UNITED STATES PATENT AND TRADEMARK OFFICE

10/760,142

| Office Action Summary | Application No. 10/760,142 | Applicant(s) GRAF, HENRY | |

Figure 1

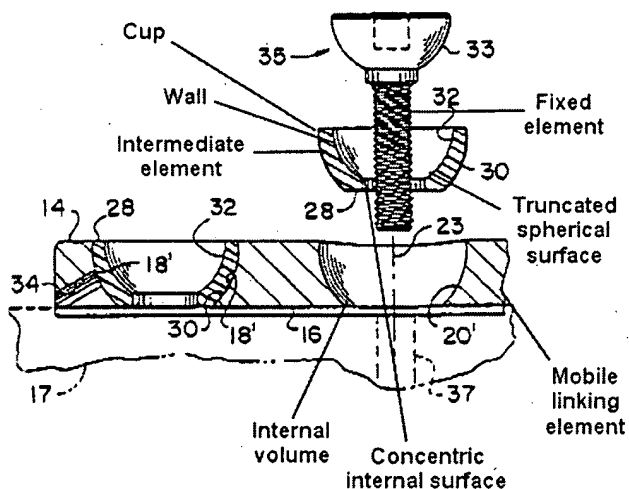
Park discloses an intervertebral linking device comprising: at least one fixed element (see Figure 1 below); at least one mobile linking element (see Figure 1 below); at least one intermediate element, wherein each intermediate element is received in an internal volume of a corresponding one of the at least one mobile linking element or of a corresponding one of the at least one fixed element, the intermediate element being deformable to be placed into the internal volume by impaction (see Figure 1 below and col. 3, lines 67-68 and col. 4, lines 1-5); and wherein the at least one fixed element or the at least one mobile linking element is received at least partially in an internal volume of the intermediate element having a mutual position of use with three degrees of freedom in rotation relative to the intermediate element while remaining linked in translation, and a mutual position of introduction in which the corresponding one of the at least one fixed element, or the corresponding one of the at least one mobile element, has three degrees of freedom in rotation and in translation relative to the intermediate element (see Figure 1 below). With regards to the three degrees of freedom in rotation relative to the intermediate element, the fixed element is capable of performing movement in three degrees of freedom. The fixed element may be capable of rotation in the x-y-z axis.

The intermediate element assumes the form of a cup (see Figure 1 below). The internal volume of the intermediate cup is bordered by a truncated spherical surface (col. 3, lines 10-13). The intermediate cup has a truncated spherical external surface,

which is concentric with the internal surface (see Figure 1 below). The internal and external surface defines a wall of the intermediate cup. The intermediate element is produced from polyethylene (col. 3, lines 67-68 and col. 4, lines 1-5).
